RE: Data Response, Set 1B
Walnut Energy Center (02-AFC-4)

WALNUT ENERGY CENTER (02-AFC-4)

DATA RESPONSE, SET 1B

Fogging Frequency Curve for
Calpine
Turlock, CA

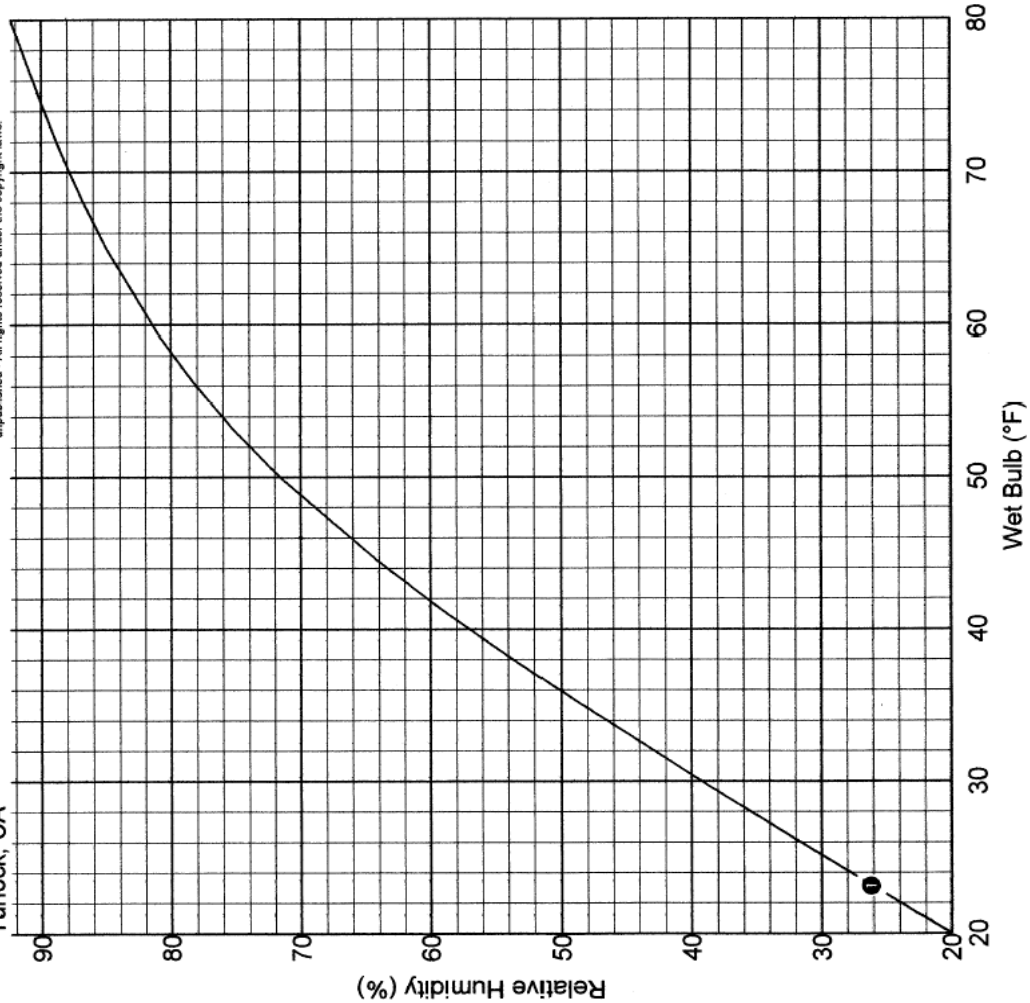
83. Please provide a fogging frequency curve from the anticipated cooling tower vendor, if available.

Response: As an example, WEC has obtained, from the Marley Cooling Tower Company, a fogging frequency curve for the anticipated cooling tower design. Marley is one potential supplier of the cooling tower for this project. This fogging frequency curve was accompanied by the following caveats from Marley:

Thus, this curve represents the potential for visible plume formation only at design heat load conditions, which are based on plant performance for the average temperature day. WEC does not have fogging frequency curves for any other design conditions.
